BIDDERS BULLETIN

PROJECT: Hitchcock Co. Schools – 2012 Addition and Remodel
Culbertson and Trenton, Nebraska

BB-1

DATE ISSUED: January 20, 2012

E3

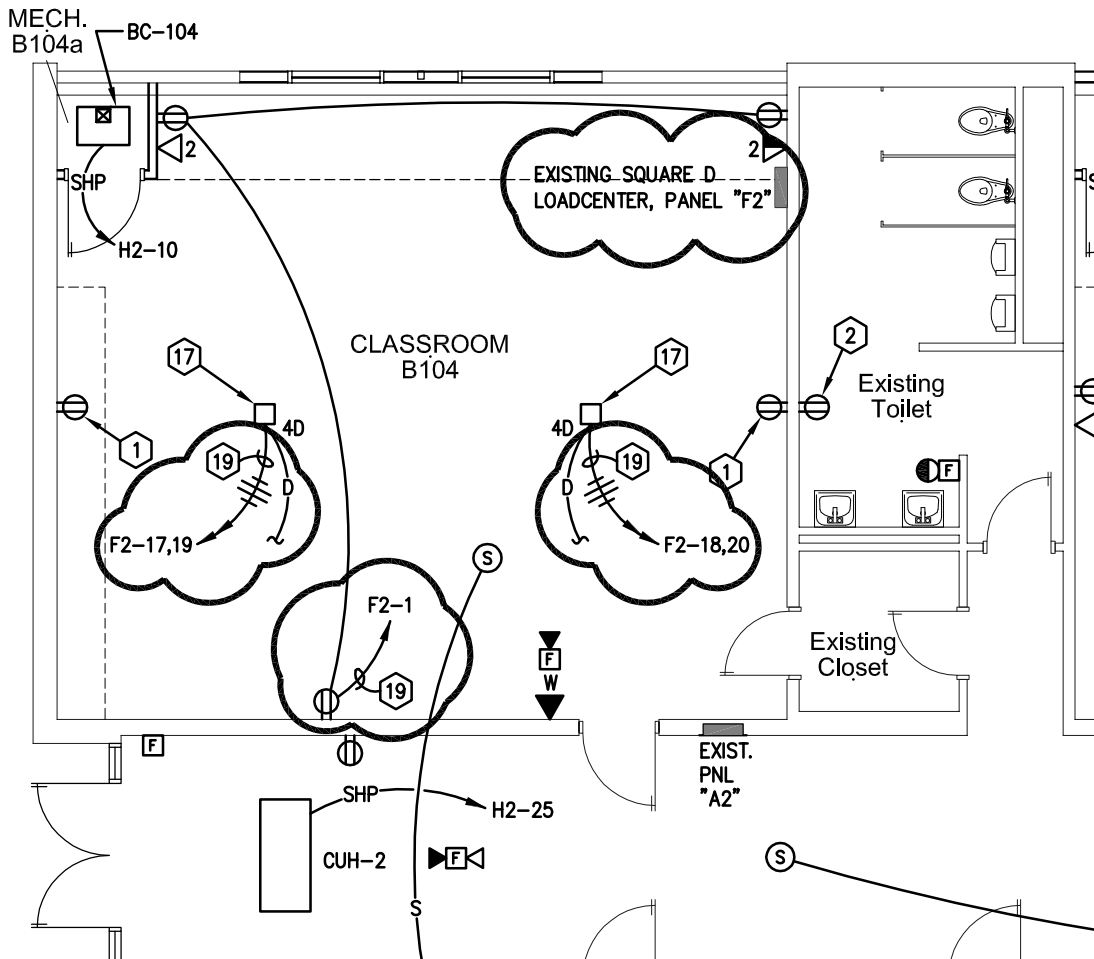
- B. Delete Ground Mounted Floodlight Detail No. 1.
- 6. Sheet E500, Electrical Symbols and Riser Diagrams
 - A. Reference Data Management Riser, attachment E3, delete RG6 cable and add Cat 6 cable to satellite, as shown on drawing.
